Americans with Disabilities Act Transition Plan Middle Keys

Volume 2 of 4

Monroe County

October 29, 2010

Women's Locker Room

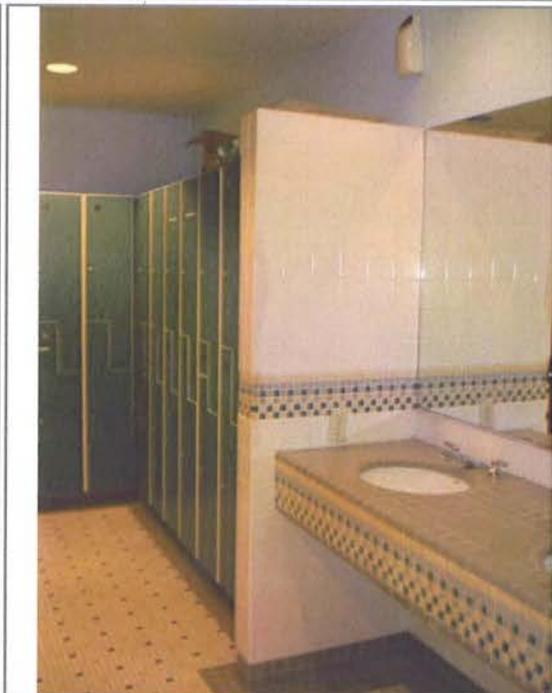
Item No.	Area/ Room	Physical Obstacle	ADA Code	Method/ Proposed Correction	Photo Page	Cost	Schedule/ Priority	Official Responsible	Status 03/27/10		
0062	Women's Locker Room	The door does not have the required maneuvering clearance on the pull side of the door.	§4.13	Rework door side partition to provide the required 18" (457 mm) min. maneuvering clearance on the pull side of the door beyond the latch side and 60" (1524 mm) min. deep clear floor area (ADAAG Fig. 25).	20	\$1,150.00	2	A/E			
0063		The door does not have the required maneuvering clearance on the push side of the door.	§4.13	Rework door side partition to provide the required 12" (304 mm) min. maneuvering clearance on the push side of the door handle side beyond the latch and 48" (1219 mm) min. deep clear floor area (ADAAG Fig. 25).	N/A	N/A	N/A	N/A			
0064		Toilet stall is does not have the required clear floor space.	§4.17	In standard stalls the front partition or at least one side partition shall provide a toe clearance of at lest 9" (230 mm) above the floor. If the depth of the stall is greater than 60" (1498 mm) then toe clearance is not required.	N/A	\$4,550.00	3	A/E

0069		Men's Locker Room	The door does not have the required maneuvering clearance on the pull side of the door.	§4.13	Rework door side partition to provide the required 18" (457 mm) min. maneuvering clearance on the pull side of the door beyond the latch side and 60" (1524 mm) min. deep clear floor area (ADAAG Fig. 25).	N/A	\$1,150.00	2	A/E		
0070	The door does not have the required maneuvering clearance on the push side of the door.		§4.13	Rework door side partition to provide the required 12" (304 mm) min. maneuvering clearance on the push side of the door handle side beyond the latch and 48" (1219 mm) min. deep clear floor area (ADAAG Fig. 25).	20	N/A	N/A	N/A			
0071	Toilet stall is does not have the required clear floor space.		§4.17	In standard stalls the front partition or at least one side partition shall provide a toe clearance of at lest 9" (230 mm) above the floor. If the depth of the stall is greater than 60" (1498 mm) then toe clearance is not required.	N/A	\$4,550.00	3	A/E

Kitchenette

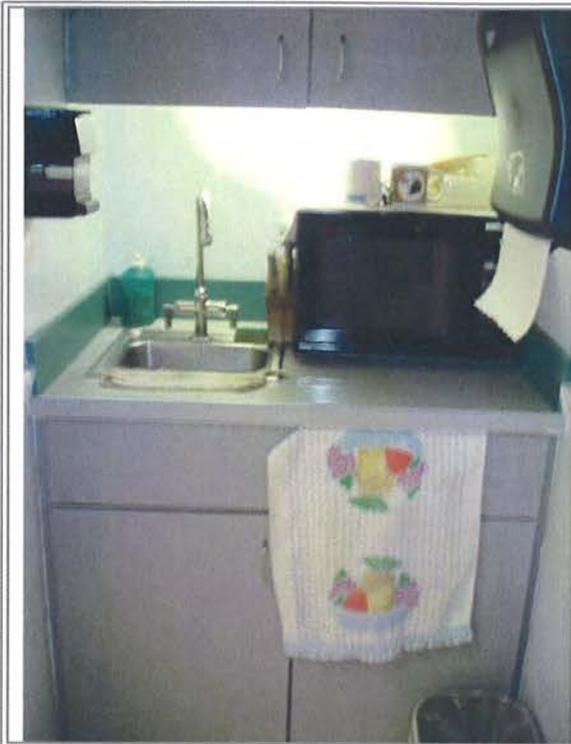
5.2 TAX COLLECTOR INTERIOR ROUTES									
0015	Kitchenette	The refrigerator does not have the required clear floor space.	§4.2	Reconfigure room's fixtures and/or offset partitions to provide the required 30" by 48" (762 mm by 1219 mm) min. wheelchair clear floor space (ADAAG Fig. 4).	13	\$6,052.63	4	A/E	
0016		Kitchen counter is mounted at 36" (914 mm) above the finished floor to the top.	§4.32	Replace counter to be mounted at 28" to 34" (711 mm to 863 mm) above the finished to the top.	13	\$1,500.00	4	Sub-contractor	
0017		Sink does not have the required knee clearance.	§4.24	Rework sink to provide a knee clearance of at least 27" (685 mm) high, 30" (762 mm) wide and 19" (482 mm) deep.	13	N/A	N/A	N/A	
0018	Drinking Fountain	Drinking fountain spout outlet (orifice height) is mounted at 38" (965 mm) above the finished floor.	§4.1	Replace fountain with hi-lo unit or install additional unit and mount at 36" (914 mm) max. above the finished floor to the spout outlet (ADAAG Fig. 27).	13	\$3,137.43	4	Sub-contractor
